King's Daughters

KD-3123.0-26

GC Services for UK King's Daughters Medical Center – Greenup Co. Urgent Care/Family Care Medical Office Building

ADDENDUM # 02

2 ADD ALTERNATE 3 - POWER/MECHANICAL POWER
1/4" = 1'-0"

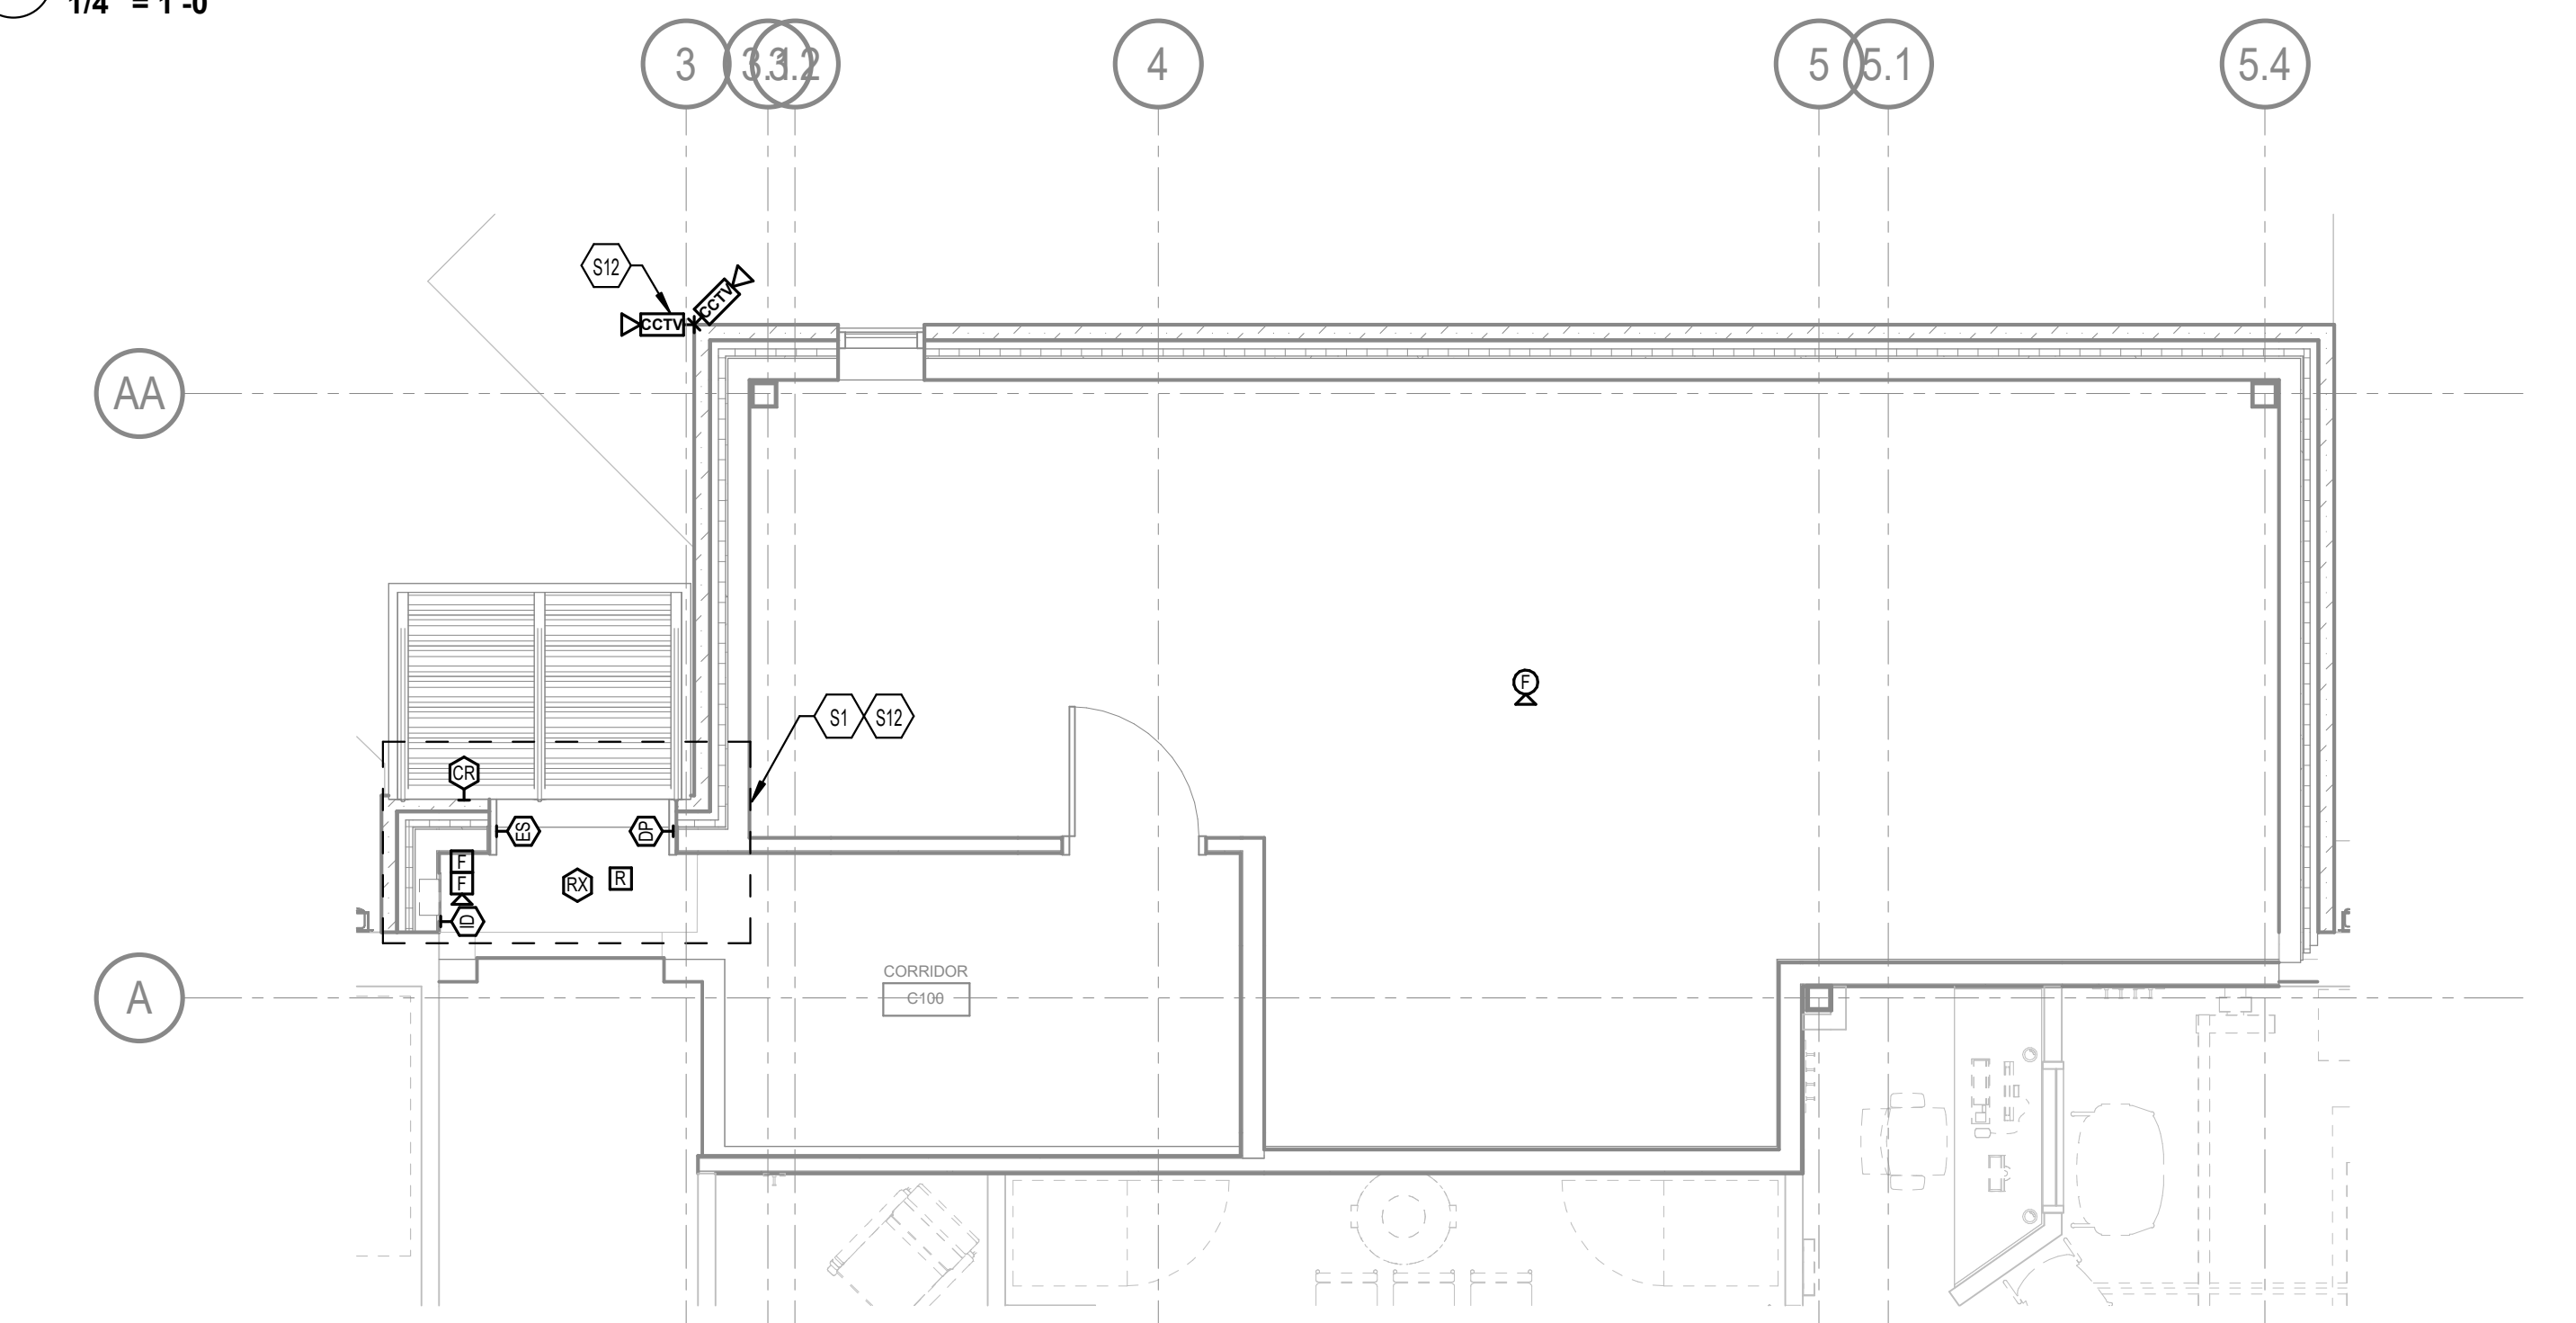
Refer to the attached revised Sheet E-601 Add Alternate 3 Plans

- View updated to show VAV-10 properly.
- Added disconnect and circuit for unit heater.
- Added disconnecting means schedule to sheet.
